REQUEST

Current Zoning: OFC (office flex campus)
Proposed Zoning: MUDD-O (mixed used development, optional)

LOCATION

SUMMARY OF PETITION

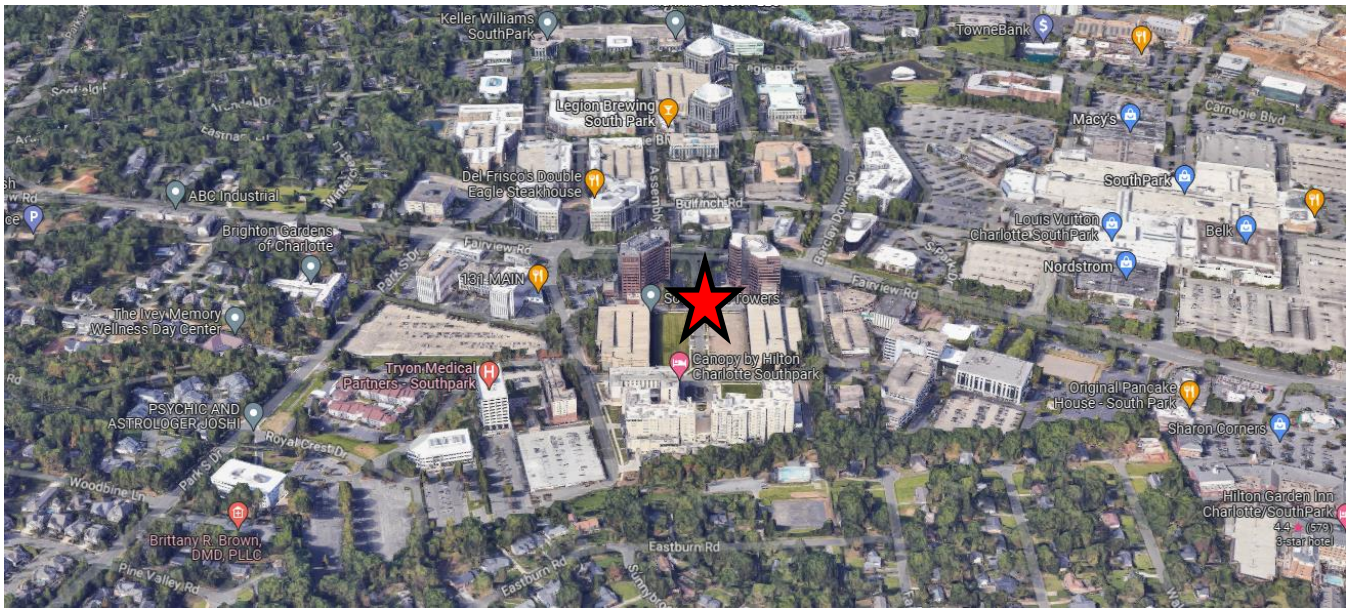
1. ~~Revise site plan and conditional note(s) to commit to dedicate 63 feet of right-of-way from the Fairview Road centerline. The site plan shall label and dimension the right-of-way from the road centerline. Addressed~~
2. ~~Update conditional note V.d.ii.iii. to change "WB" to "EB" as the southern crosswalk is along the eastbound direction on Fairview Road. Addressed~~

3. ~~Design standards are inadequate. If the petitioner does not want to incorporate new UDO standards, reference and incorporate standards from RZP 2020-059 as a baseline. Addressed~~
4. ~~Amend Design guideline note b.7 to specify a building height in feet for stepbacks rather than stories. Addressed~~
5. ~~Amend references to "primary building façade" throughout the design guidelines and use "elevations facing public rights-of-way" or define primary building façade and highlight locations on the site plan. Addressed~~
6. ~~Remove or amend the last sentence of Transportation note V.d. related to trigger Loop commitments. Addressed.~~

7. ~~Amend the optional provision #2 related to existing parking to include Area B as there is existing parking between the building and Barclay Downs Dr. Addressed~~
8. ~~Include note that any changes to the existing buildings will not increase their degree of nonconformity. Addressed~~
